**AMENDMENTS TO THE DRAWINGS**

Appln. No. 10/712,764  
Amdt. dated March 14, 2005  
In response to Office action mailed Dec. 14, 2004

Appl. No. 10/712,746  
Amd. dated March 14, 2005  
In response to Office action mailed Dec. 14, 2004  
Annotated Sheet Showing Changes Made

FIG. 6

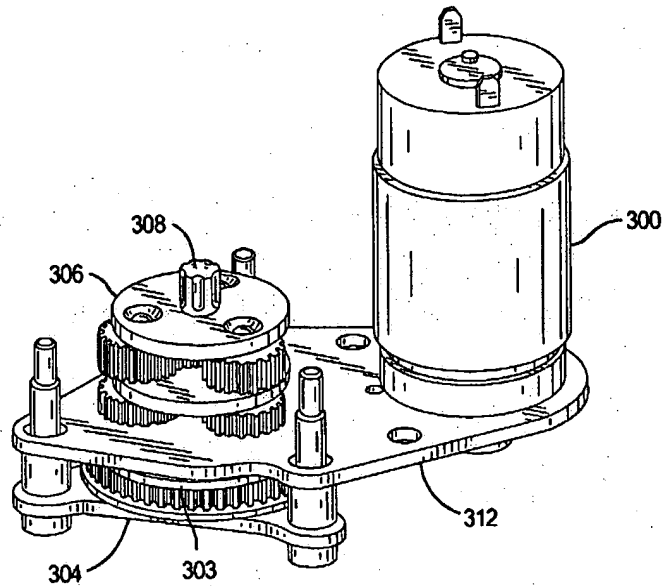
Finally, the drawings were objected to because FIG. 7 is turned sideways to the view in FIG. 3, and FIG. 6 is turned upside to the view of FIG. 3. Applicants respectfully submit that the orientations of the various figures have been selected to best illustrate various aspects of an actuator consistent with the disclosed subject matter. Additionally, Applicants believe that a person having ordinary skill in the art should be able to recognize the changes in orientation and appreciate the corresponding attributes of the various drawings. Applicants respectfully submit, therefore, that no changes to the drawings are necessitated by the selection of view chosen for the various figures. It is respectfully requested that this objection be withdrawn upon reconsideration by the Examiner.

FIG. 8

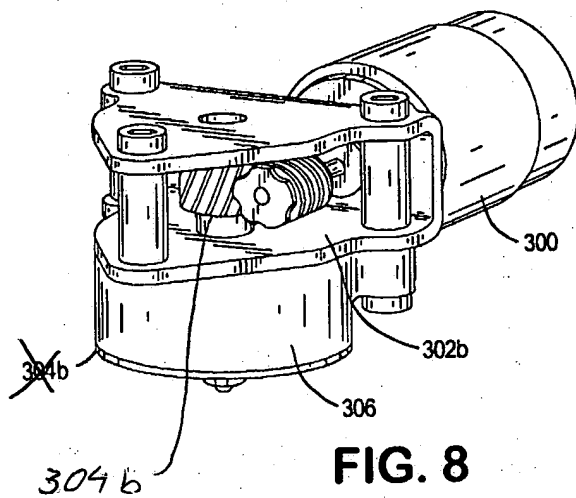
The attached sheets of drawings include changes to FIG. 7 and FIG. 8. The first sheet, which includes only FIG. 7, replaces the original sheet, which also included only FIG. 7. In FIG. 7, previously omitted phantom lines, showing the assembly of the exploded view, have been added. The second sheet includes FIG. 6 and FIG. 8. In FIG. 8, the leader line from reference numeral 304 has been amended to indicate the worm wheel, referenced in the specification.

In the specification, the paragraph beginning on page 8, line 21 has been amended to replace the reference numerals 202b and 204b with the reference numerals 302b and 304b as shown in FIG. 8 of the drawings. No new matter is believed entered by this amendment.

The drawings were also objected to because reference numerals 202b and 204b, recited in the specification, are not included in the drawings. The specification has been amended on page 8, line 21 to correct the minor clerical error whereby the reference numerals were misstated. Page 8, line 21 of the specification has been amended to properly recite “a worm gear 302b and worm weal 304b” as indicated in FIG. 8. No new matter is believed entered by this amendment. Applicants respectfully request that this objection to the drawings be withdrawn upon reconsideration. Furthermore, FIG. 8 has been amended to extend the leader line of reference numeral 304b to more clearly indicate the worm wheel. This aspect of the drawing was clearly shown in the originally filed informal drawings. Accordingly, no new matter is believed entered.
